Sundry ID: 2642273

**Plug and Abandonment Procedure**  
**for**  
**DJR Operating, LLC**  
**Jicarilla Apache I 2**  
**API # 30-039-05139**  
**NE/SE, Unit I, Sec. 2, T23N, R3W**  
**Rio Arriba County, NM**

Attachment to notice of Intention to Abandon

# BLM FLUID MINERALS P&A Geologic Report

Current Wellbore Diagram  
DJR Operating, LLC  
Jicarilla Apache I 2  
API # 30-039-05139  
NE/SE, Unit I, Sec 2, T23N, R3W  
Rio Arriba County, NM

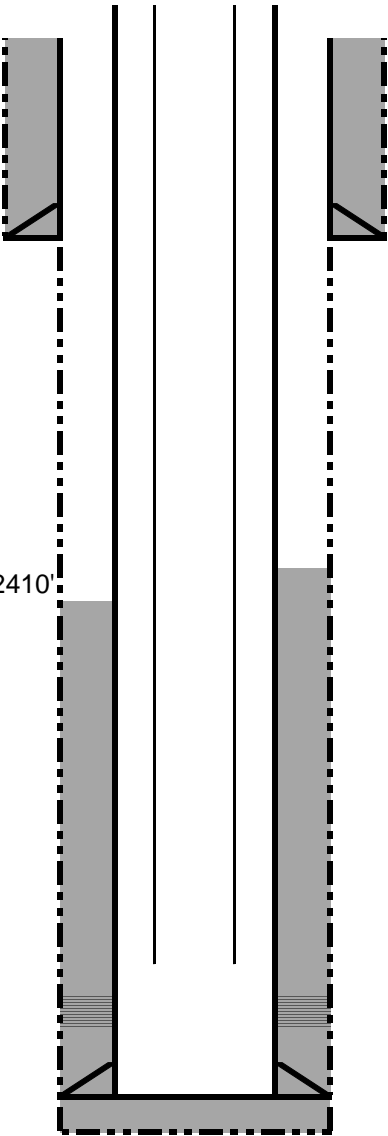
1. Plugging operations authorized are subject to the attached "General Requirements for Permanent Abandonment of Wells on Federal and Indian Lease."
2. Farmington Office is to be notified at least 24 hours before the plugging operations commence at (505) 564-7750.
3. The following modifications to your plugging program are to be made:
  - a. Plug 2 (Nacimiento) – Adjust or add a plug to cover BLM formation top pick at 1382 feet.

- BLM picks for the Fruitland and Nacimiento formation tops vary from Operator picks.

- Adjust Plug #2 (Nacimiento) to cover BLM formation top pick at 1382'.
